**Architectural Review Committee Staff Report
Department of Planning and Building
Town of McCordsville**

- Project:** Woodhaven
- Petitioner:** Fischer Homes
- Request:** The petitioner is seeking approval of the addition of model/elevations to their current line-up in Woodhaven.
- Staff Review:** The petitioner would like to introduce 1 new model with three elevations to their Maple Street Series (R3 & R4 Areas of Woodhaven).

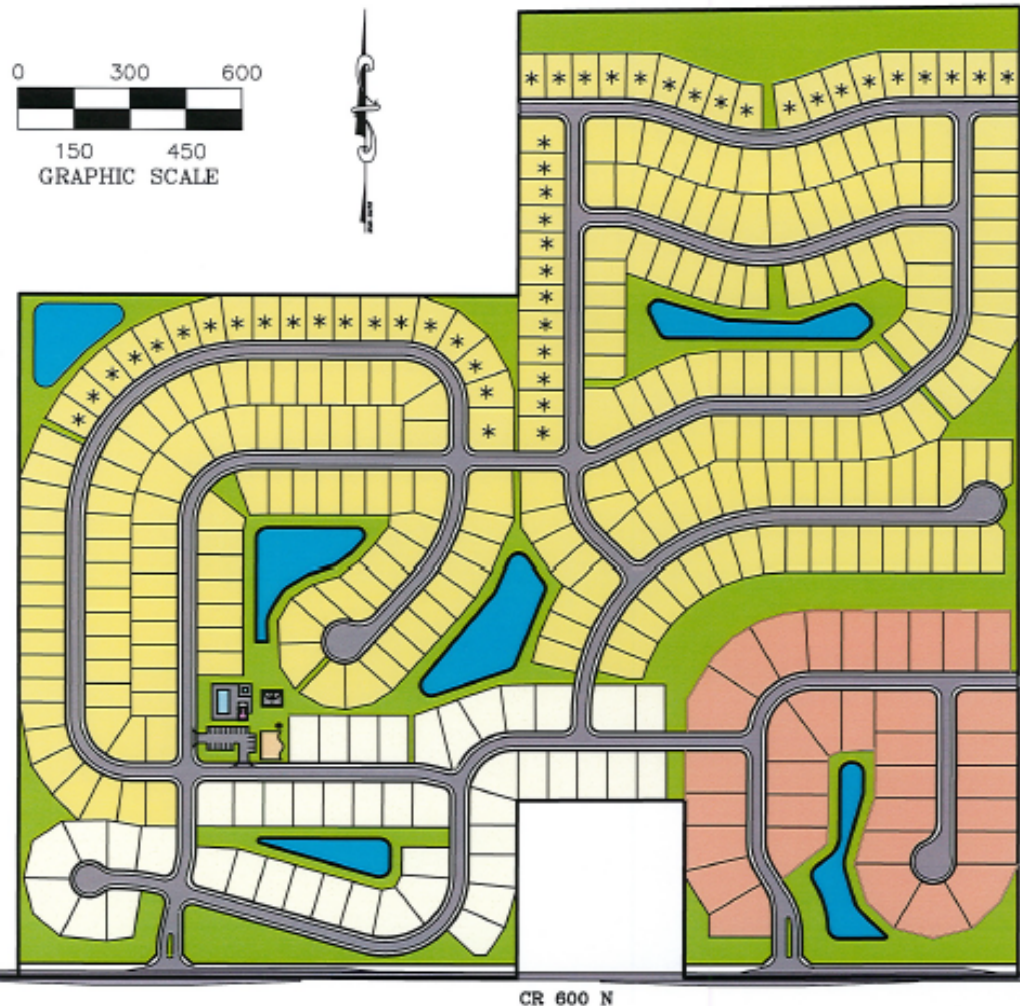
Staff has denoted a few concerns and we have relayed those to the petitioner. Once we hear back, we will update this staff report. Furthermore, we have requested side and rear elevations of this model. Staff is still working on the anti-monotony review and will provide that prior to the meeting.
